## NRDC Comments on ENERGY STAR's Version 6 Proposal For New TVs

Noah Horowitz, Senior Scientist  
Natural Resources Defense Council  
[nhorowitz@nrdc.org](mailto:nhorowitz@nrdc.org)

June 20, 2011

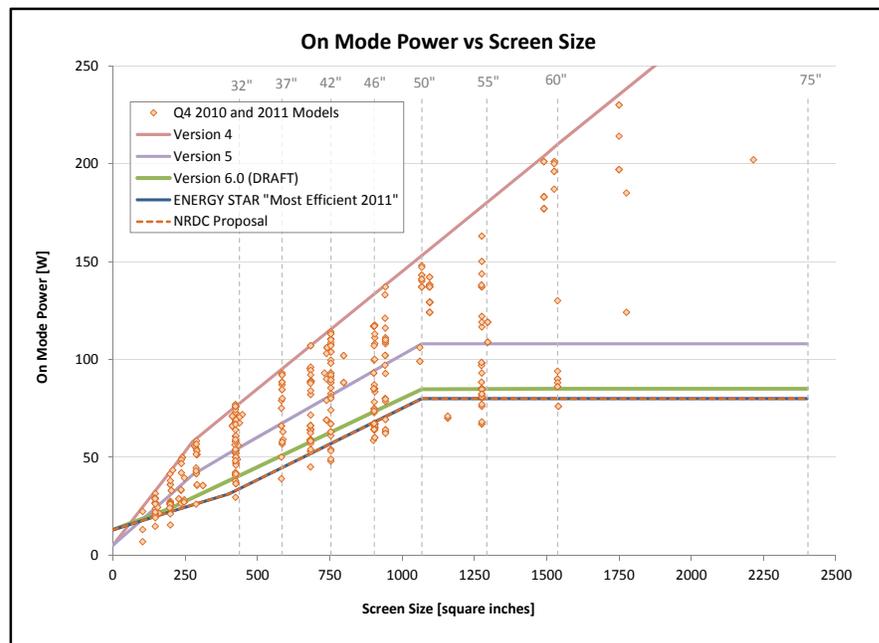
1. **On Mode Power Levels** – *NRDC strongly supports ENERGY STAR's proposed on mode power limits for version 6.0.* NRDC would also be supportive of ENERGY STAR adopting the current ENERGY STAR Most Efficient 2011 specification as ENERGY STAR 6.0. Below is a plot of the various specification requirements for existing and potential future on mode power levels (note each data point may represent numerous qualifying models).
